Informal document **GRPE-69-08**
(69th GRPE, 5-6 June 2014
agenda item 4(b))

Proposals for amending R49 Rev 6

(Document TRANS/WP.29/GRPE/2014/12)

Transposing the latest EU OTLs and their date of application

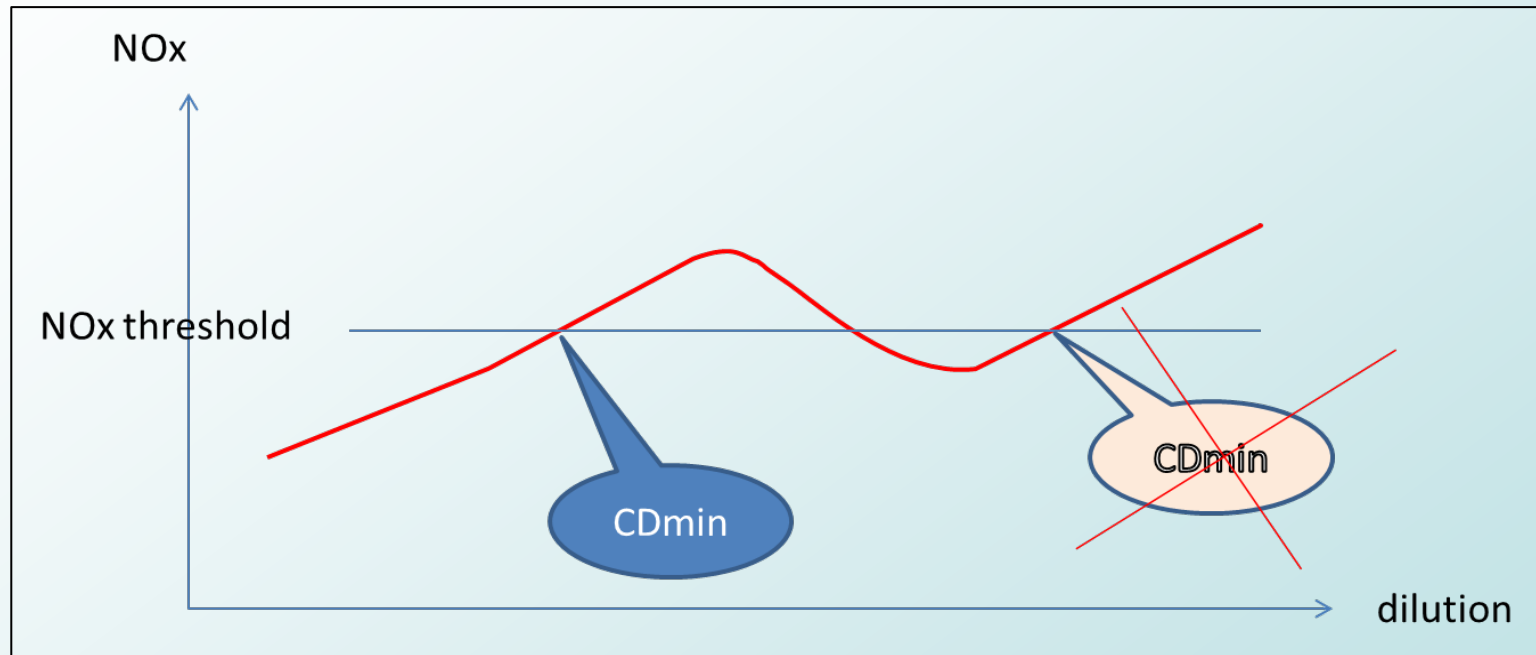
- Introduction of the CO OTL for gas engines as from “letter B”
- Introduction of the PM OTL (“soot sensor”) as from “letter C”
- For LCVs: introduction of the optional OTL equivalency with the ones of the cars (alternative type-approval)
